DOCUMENT 00 91 01 –

ADDENDUM NO. 02

P2.2

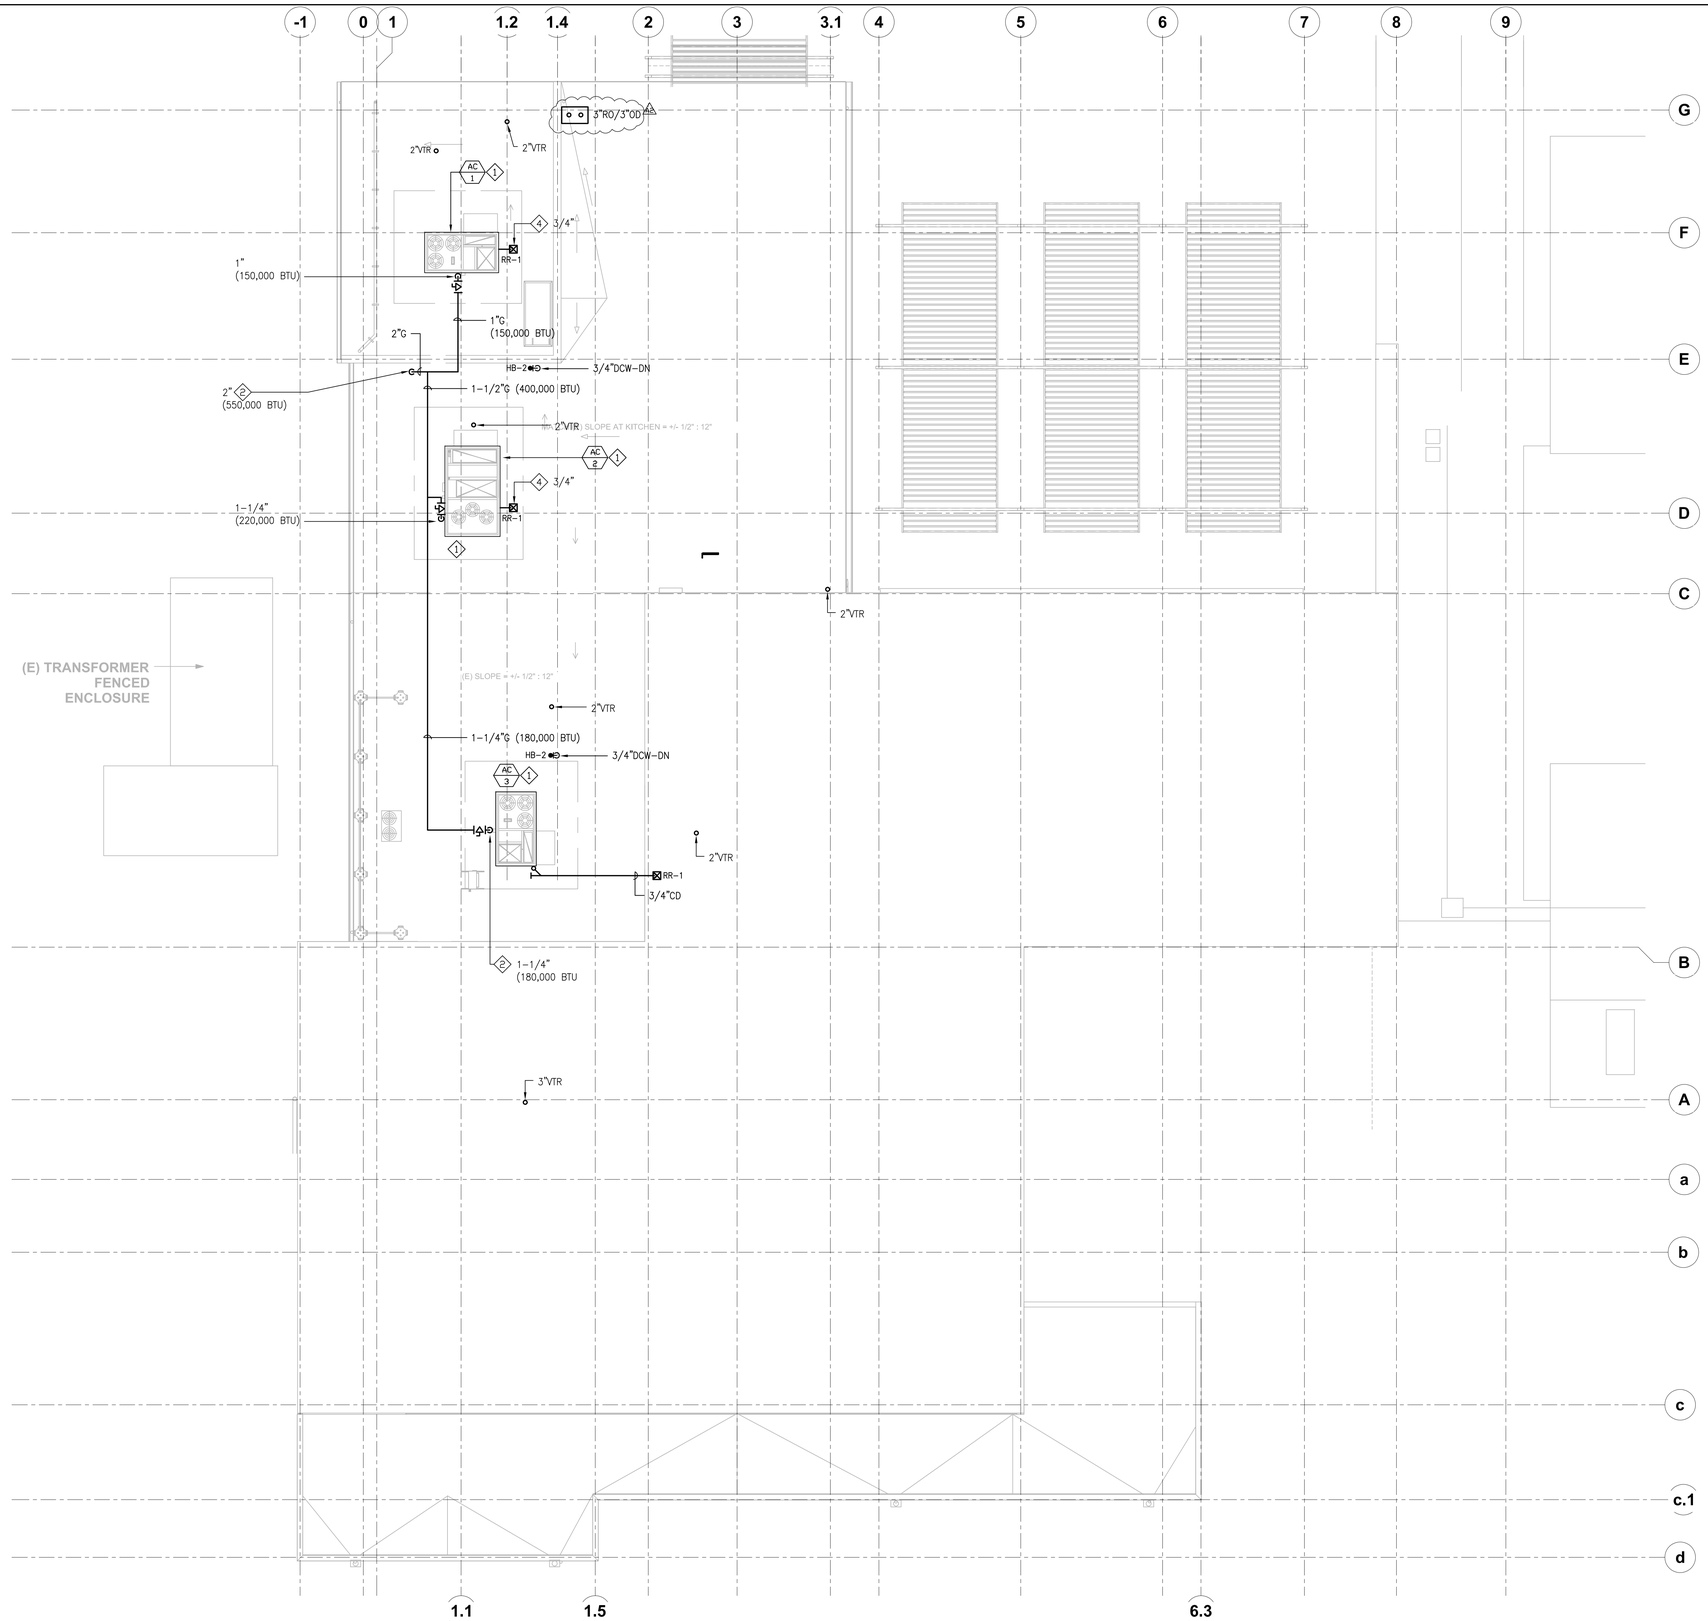
Sheet P2.2 - Plumbing Roof Plan
A. Revised roof to include overflow drain at north end of roof.

E2.1

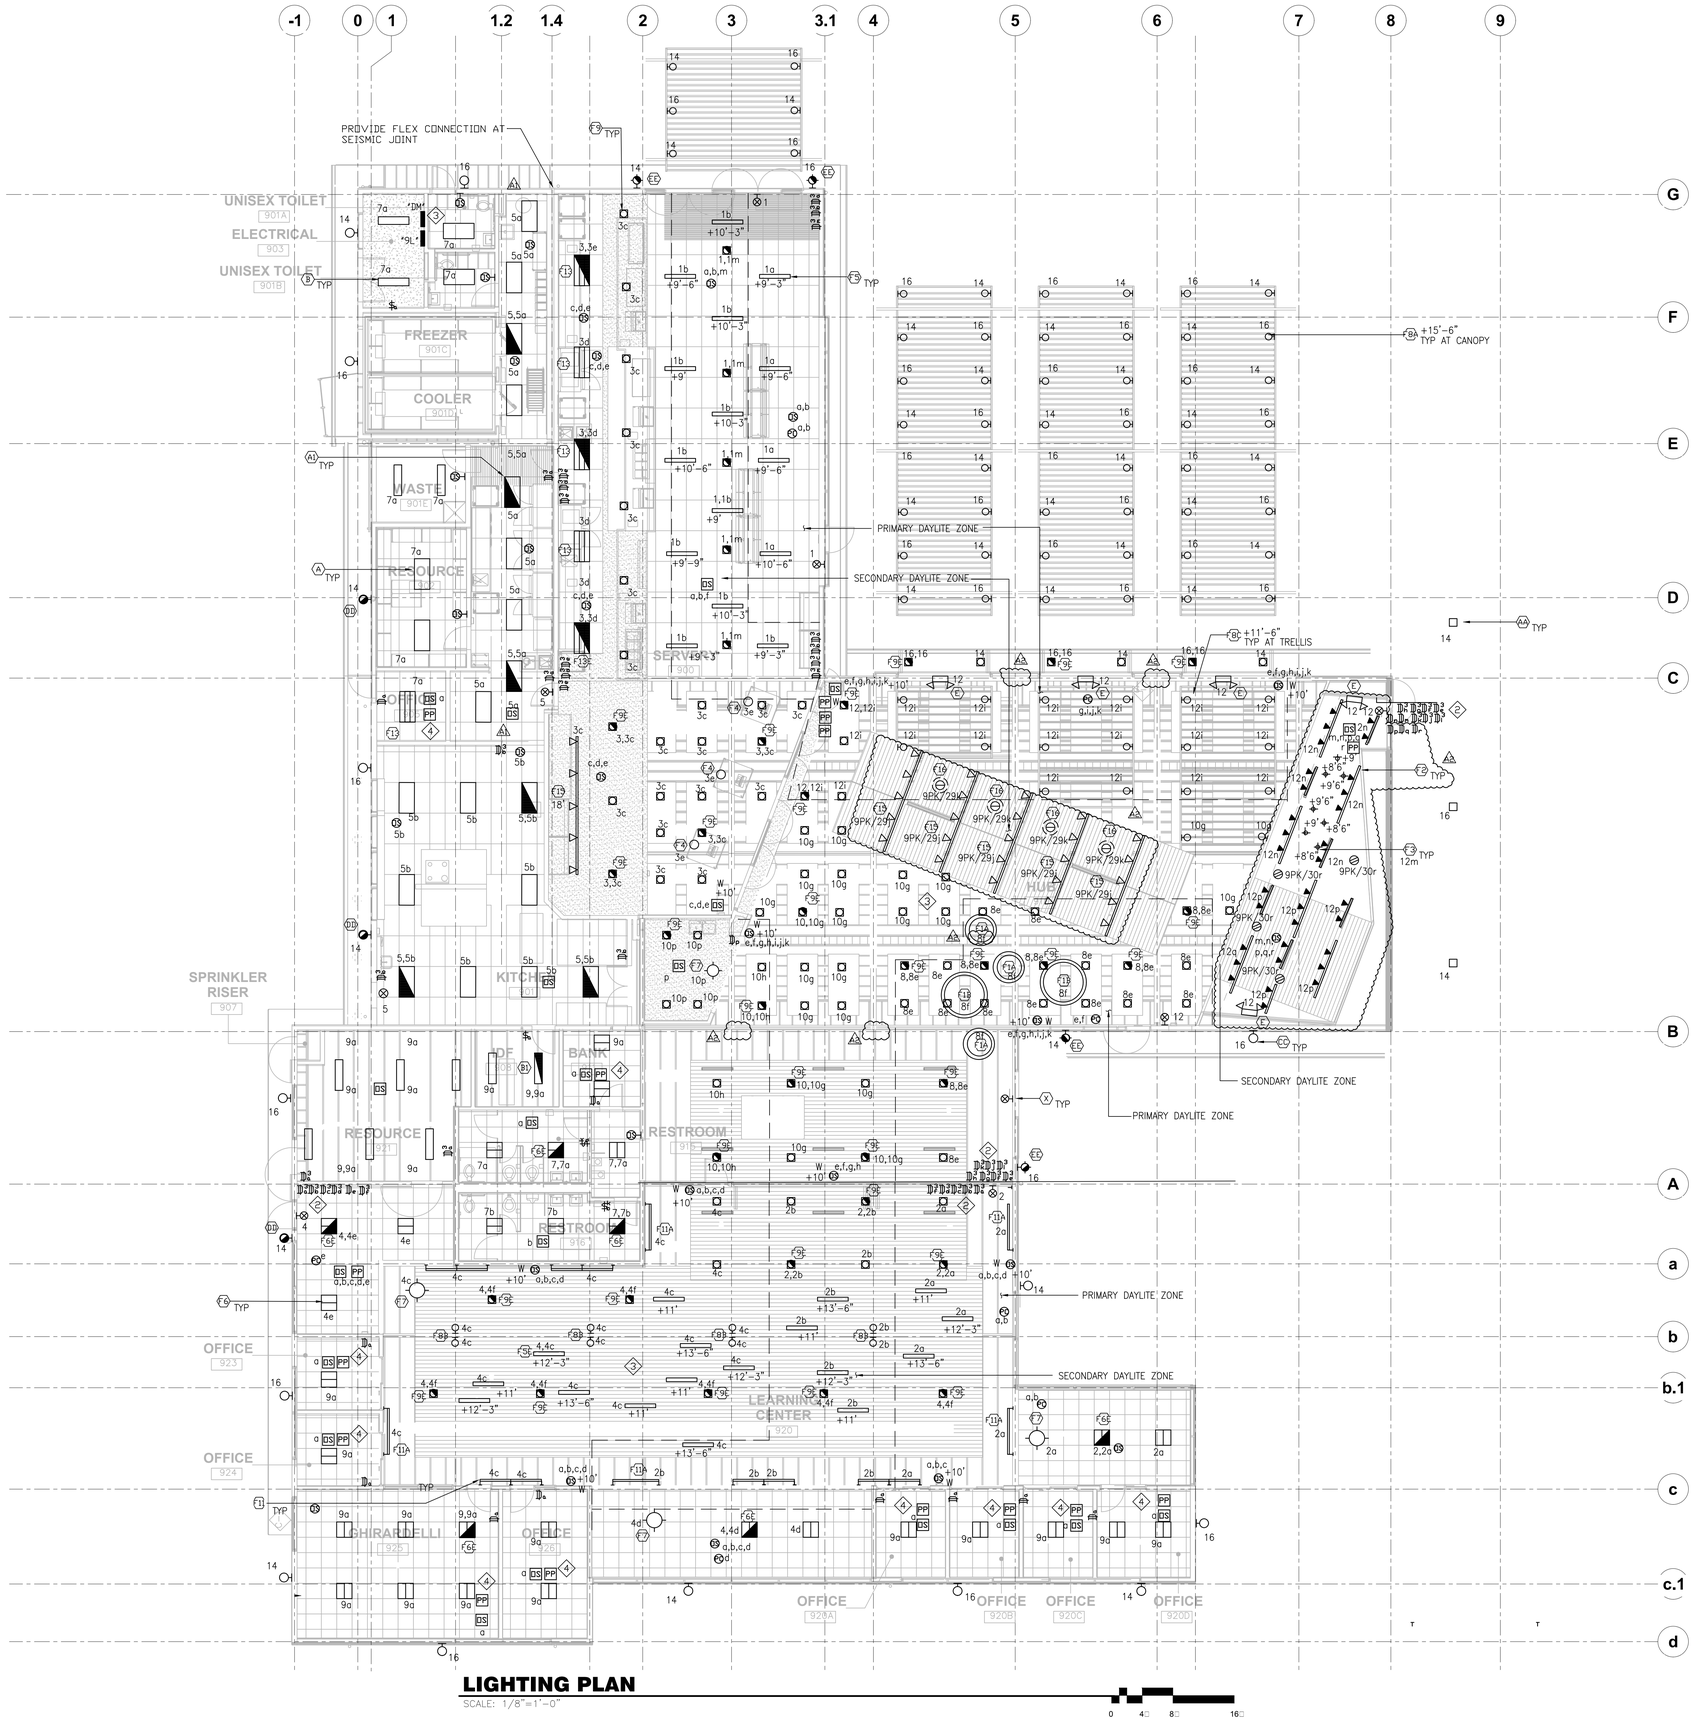
Sheet E2.1 - Lighting Plan
A. Deleted (7) type "F8B" column fixtures
B. Revised fixture layout / control zones at stage
C. Revised circuitry at trellis fixtures

E2.2

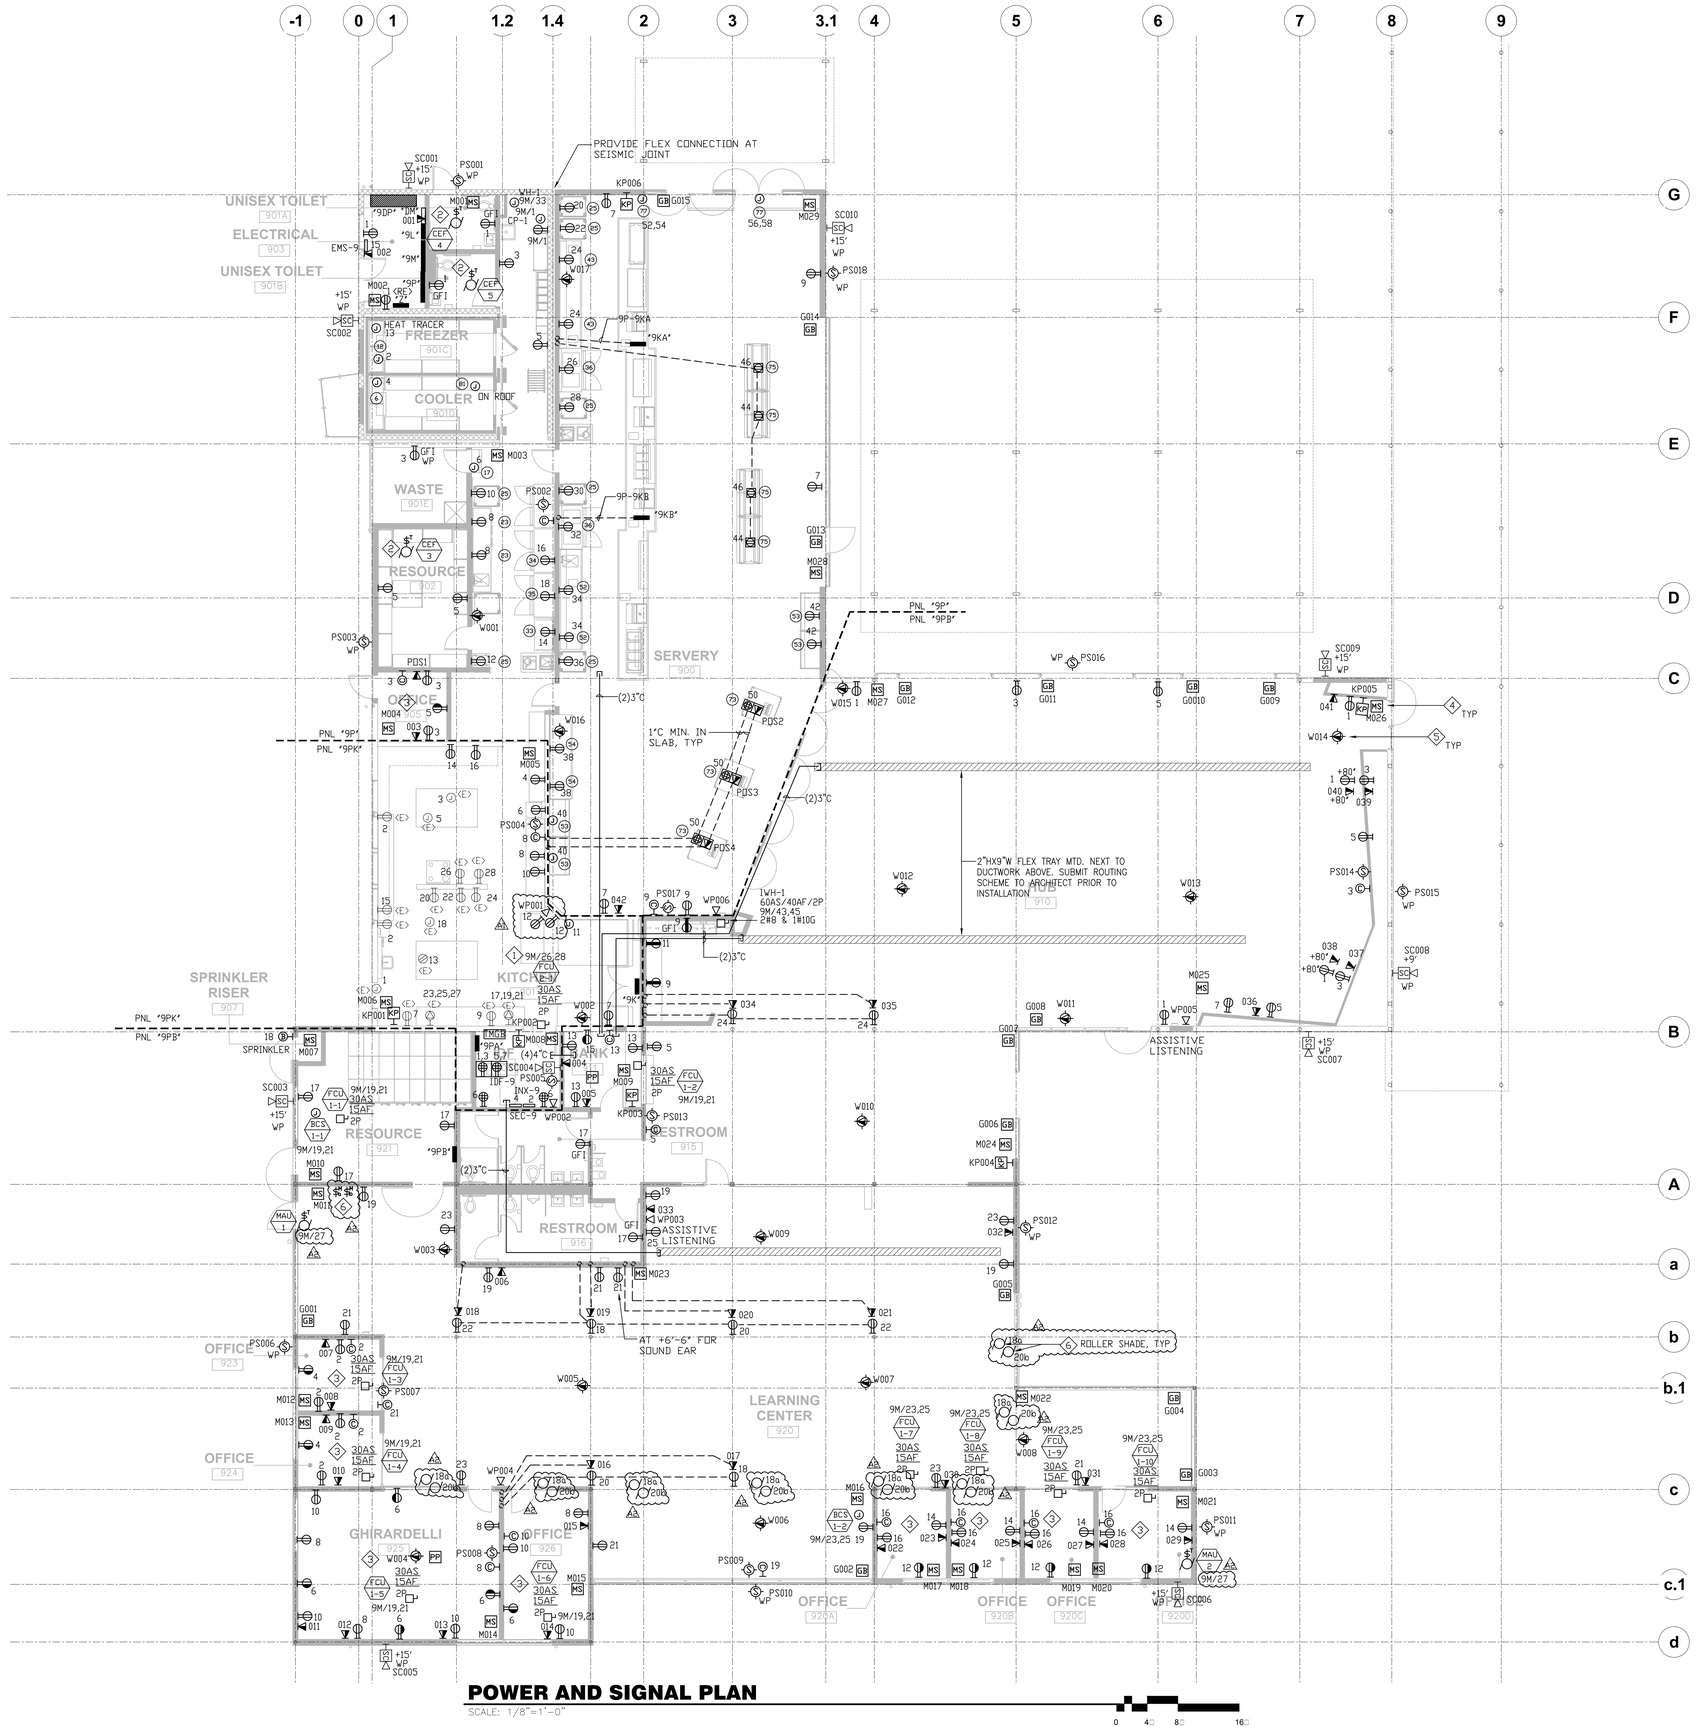
Sheet E2.2 - Power & Signal plan
A. Revised circuits for MAU-1 and MAU-2 to 9M/27 in lieu of 9PB/27.
B. Provide power connection for roller shades

ROLLER SHADE CONTROL WIRING DIAGRAM
NOT TO SCALE

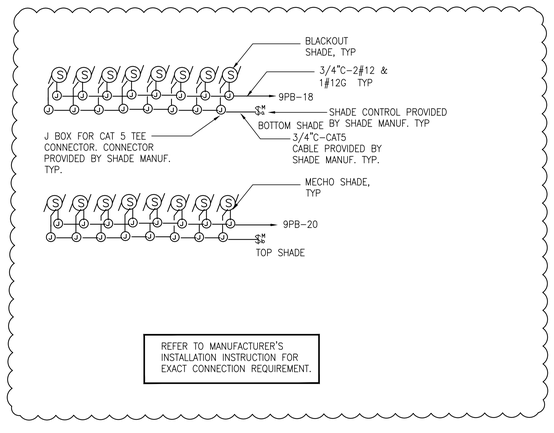
Sheet E5.1, Wiring diagrams
A. Added Roller Shade control wiring diagram 3/E5.1
